| Well Name: CUTIE PATUTIE       | Well Location: T30N / R14W / SEC 9 / NWSE / 36.825849 / -108.311165 | County or Parish/State: SAN JUAN / NM |

Notice of Intent

Type of Submission: Notice of Intent      Type of Action: Plug and Abandonment

### Notice of Intent – Plug and Abandonment

**Planned P & A Wellbore Schematic**

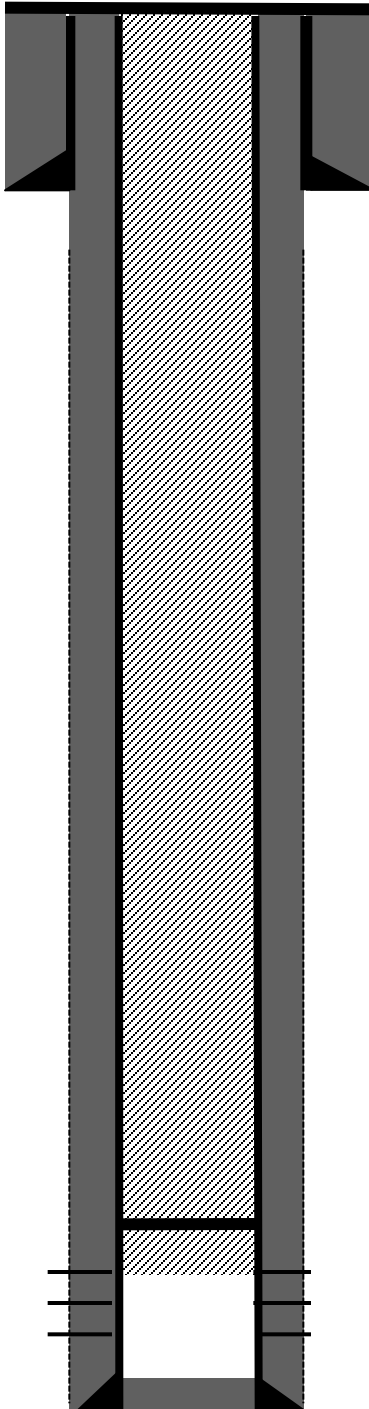
1. Plugging operations authorized are subject to the attached "General Requirements for Permanent Abandonment of Wells on Federal and Indian Lease."
2. The following modifications to your plugging program are to be made:
  - a. Complete well bore fill up proposal. No changes to the procedure.
3. **Notification:** Farmington Office is to be notified at least 24 hours before the plugging operations commence at (505) 564 7750.

Complete wellbore fill up proposal. No changes to the procedure.
